**MODIFICATION REQUEST:  
Riverwood North Estate Residential  
Renewal Project  
Kentucky Road and Washington Avenue,  
Riverwood  
(MP 10\_0167 MOD 1)**

***Modification to maximum building envelope  
heights***

Director-General's  
Environmental Assessment Report  
Section 75W of the  
*Environmental Planning and Assessment Act 1979*

September 2011

Figure 5: Proposed modified layout Phase 2 Stage 1

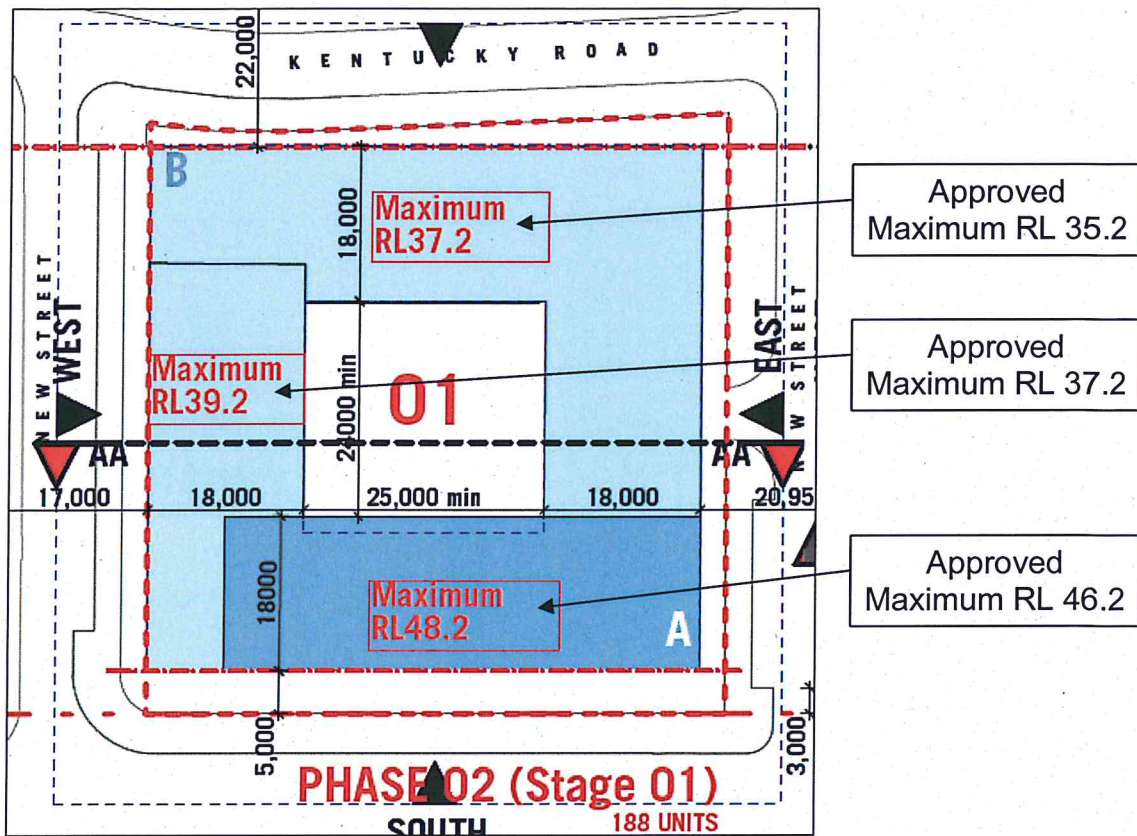
The key aspect of the proposed modification is increases to the heights of the building envelopes for Phase 2 of the development ranging from 0.3 metres to 2 metres (see Appendix A).

In preparing the development applications, the proponent has undertaken further design development which has revealed that the height of the envelopes in the original environmental assessment for the concept plan would need to be increased to meet minimum stormwater overland flow flooding requirements. Flood modelling undertaken to inform the detailed design of the buildings within Phase 2 has revealed that the ground floor levels need to be positioned above existing kerb levels and have a minimum 300 mm freeboard. This subsequently resulted in the need to raise ground floor levels by up to 1.11 metres (from RL 18.00 to RL 19.11 for Stage 1) to mitigate any potential flooding impacts from stormwater overland flow, which consequently requires the height of the building envelopes to be increased. Due to the sloping nature of the site increases of up to 1.11 metres are required to ensure that the ground floor cleared the highest kerb for the block to maintain alignment of the podium level.

The proponent has also sought to increase the heights by up to an additional one metre for some of the building envelopes to accommodate 3.1 m floor to floor heights to provide additional capacity for servicing and comply with the minimum 2.7 m floor to ceiling height requirement in the Residential Flat Design Code. The approved heights compared with the proposed heights are shown in Table 1.

The department considers that the modifications sought for minor RL height increases to building envelopes can be supported as they would have negligible amenity impacts and are necessary to provide flexibility for future buildings to address minimum stormwater flood level clearance requirements. Accordingly, the department recommends that the approved plans identified in the Instrument of Approval be modified to identify the increased heights varying from an additional 0.3 metres to 2 metres.
